## **STANDARD FIELD SERVICE BULLETIN**

FSB Number	CHRAEFSB2017-19 <a href="#">Rev. 4</a>
Author	Tony Bryan
Date	11/03/2017
Subject	Moto G4 Plus, Moto G4 - Touch Screen, Auto-Selects (ghost touches)
Model Affected	XT164x, XT162x
Level Of Repairs	Level 2

**F-Hsg Assembly Level Sorting Method By Flex Pattern**

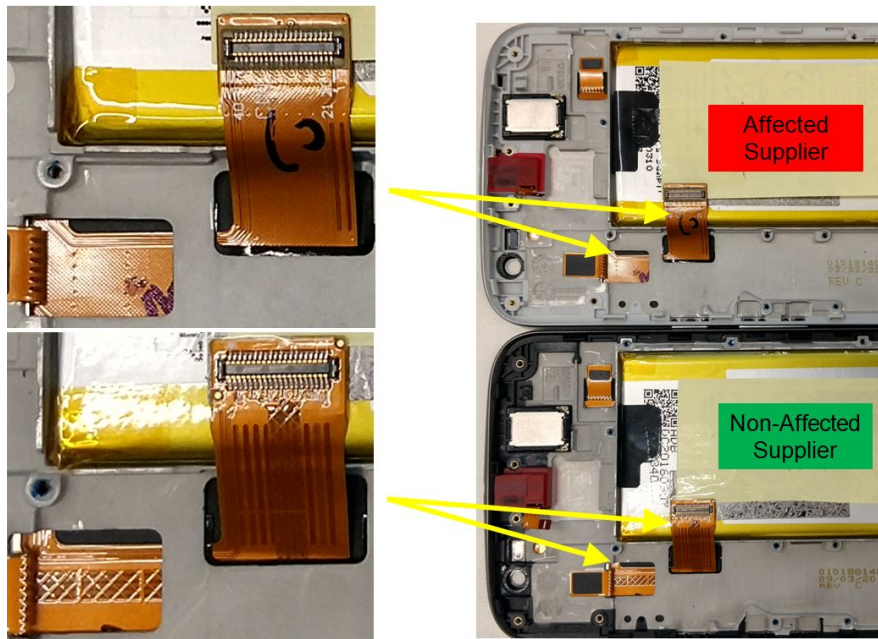
**NOTE:** Affected F-Hsg Assy (P/N: 01018796001/2W / 01018859001/2W) can be visually sorted further using the provided image below, calling out display flex pattern differences, to help identify Display/Touch Panel part numbers.

**Note:** As of September 2017, the Affected Supplier started adding a black colored dot on the Display Flex Connector as shown above to help identify post corrective action material at the F-Hsg Assy Level.
